# akaysha

30 August 2023

**Response to AEMO 2023 Technical Requirements Recommendations**

## 1.1 Treatment of reactive power capability considering temperature derating

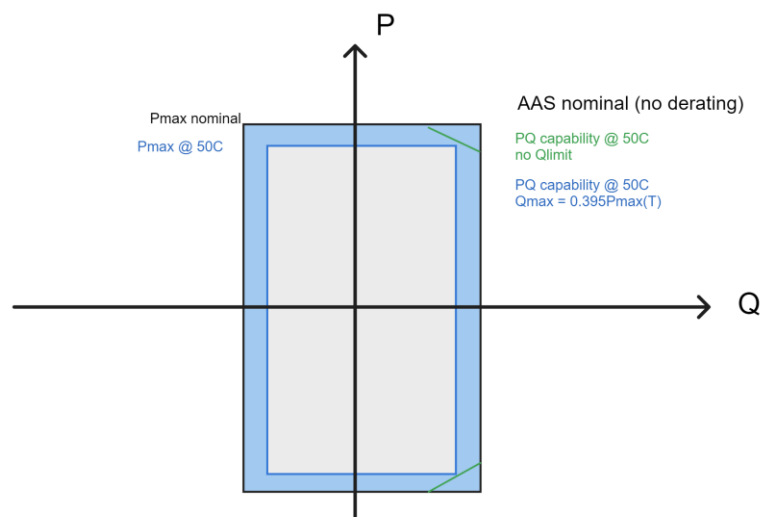
- We are not in favour of AEMO electing to standardise the temperature based reactive power performance as a function of  $0.395P_{max}(T)$ . Many inverter OEMs by default implement a maximum current limit part of the temperature derating functionality. This means that given that most GPS compliant plants are set to Qpriority, where even at  $P_{max}$ , the  $Q_{max}$  that is capable to be delivered is more than  $0.395P_{max}(T)$ . We believe that,

- From a system perspective, it would be beneficial for the grid to have more reactive capability available since the generators already have the capacity installed. As per AEMO’s comment regarding NEO requirements, Akaysha believes that it would be prudent to leverage existing plant capability that is installed for CUO requirements at 35C, and

- From a control algorithm / product design perspective, this new feature is an added layer of live sensor derived response and a technically difficult point of failure that doesn’t add value to the inverter’s performance or product integrity. We are supportive of the GPS modelling and capturing temperature derating but we believe that the practical temperature derating should remain at the inverter level without an overarching site POC forced derating layer.

As an example, the following sketch demonstrates the maximum capability for an arbitrary plant with respect to AAS at a nominal temperature before the inverter starts to derate e.g. 35C (black) and at 50C, where green indicates the 50C performance with no explicit  $Q_{lim}$  and blue indicates the 50C performance with linear scaling of  $0.395P_{max}(T)$ .
